UNITED STATES PATENT AND TRADEMARK OFFICE

APPLICATION NO.	FILING DATE	FIRST NAMED INVENTOR	ATTORNEY DOCKET NO.	CONFIRMATION NO.
10/658,308	09/09/2003	Charles J. Renz	460.2173USX	2142

Office Action Summary

DETAILED ACTION

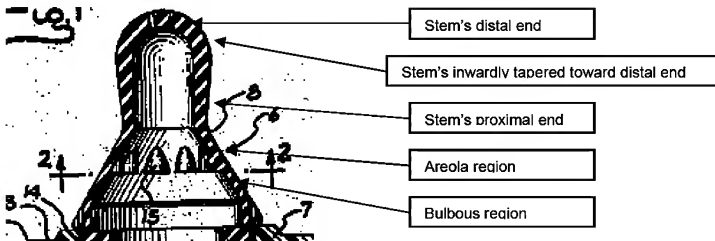
2. Claim 34 is rejected under 35 U.S.C. 102(b) as being anticipated by Witz (US 2960088).

Note in figure 1 of Witz, a stem (as shown in fig. below) having orifice (19), proximal and distal ends (as shown in fig. below); an areola region connected to the proximal end of said stem; and a bulbous region being connected to said areola region, wherein said areola region is substantially concentrically aligned with said bulbous region when viewed in a top view and wherein said proximal end of said stem has opposing sides with inwardly concave shapes when view in a front view; and wherein said areola region and said proximal end of said stem are connected along an inwardly concave surface and wherein said inwardly concave surface is smooth.

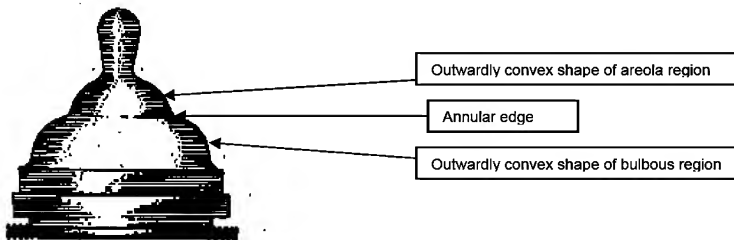
4. Claims 37-40 and 43 are rejected under 35 U.S.C. 103(a) as being unpatentable over Witz (US 2960088) in view of Porthouse et al. (Des. 130,791).

Witz discloses the claimed invention (as state above) except for the outwardly convex shape of the bulbous and areola regions and the annular edge disposed thereof.

Porthouse et al appears to teach that it is known in the art to have the outwardly convex shape of the bulbous and areola regions and the annular edge disposed thereof (as shown in fig. below).

For this reason, it would have been obvious to one of ordinary skill in the art at the time the invention was made to modify nipple of Witz by having the outwardly convex shape of the bulbous and areola regions and the annular edge disposed between the areola and bulbous regions as taught by Porhouse et al in order to enhances the comfort of baby's mouth while sucking on the nipple.
